Access Compliance Report

Public Rights-of-Way

(Curb Ramps)

Intersection ID: 50338	Main Street: HERMISTON_ST	Cross Street: CASTLECOVE_RD	Location: SE
ADA ID: F90A71446A51	Ramp Type: PerpDiag	Initial Pass/Fail: Fail	Overall Compliance: No
		Severity Score: 12.5

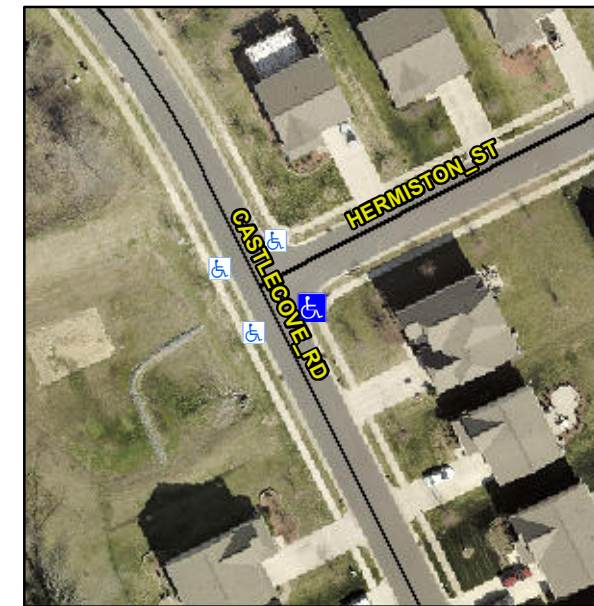
Compliance	Description	Data	Compliance	Description	Data
N/A	Ramp Length (in)	49.0	No	Ramp Slope (%)	11.8
Yes	Ramp Width (in)	48.0	Yes	Ramp XSlope (%)	0.3
N/A	Flare Type LT	N/A	N/A	Flare Type RT	N/A
N/A	Flare Slope LT (%)	N/A	N/A	Flare Slope RT (%)	N/A
N/A	Flare Traversable LT?	N/A	N/A	Flare Traversable RT?	N/A
N/A	Landing Length (in)	N/A	N/A	DWS Provided?	N/A
N/A	Landing Width (in)	N/A	N/A	DWS Contrast?	N/A
N/A	Landing Slope (%)	N/A	N/A	DWS Length (in)	N/A
N/A	Landing X Slope (%)	N/A	N/A	DWS Full Width?	N/A
N/A	Landing Curb? (Y/N)	N/A	N/A	DWS Offset (in)	N/A
N/A	Shared Landing?	N/A			
N/A	Gutter Ponding?	N/A	N/A	Gutter Slope (%)	N/A
N/A	Gutter Lip Ht (in)	N/A	N/A	Gutter X Slope (%)	N/A
N/A	Painted X Walk1?	No	N/A	Painted X Walk2?	No
	X Walk 1 Direction	To NW		X Walk 2 Direction	To SW
N/A	X Walk 1 Width (in)	N/A	N/A	X Walk 2 Width (in)	N/A
	X Walk 1 Slope (%)	0.5		X Walk 2 Slope (%)	4.1
	X Walk 1 X Slope (%)	0.0		X Walk 2 X Slope (%)	1.3

Remove & Replace Curb Ramp With Two New Directional Ramps or Equivalent.

R304.2.2
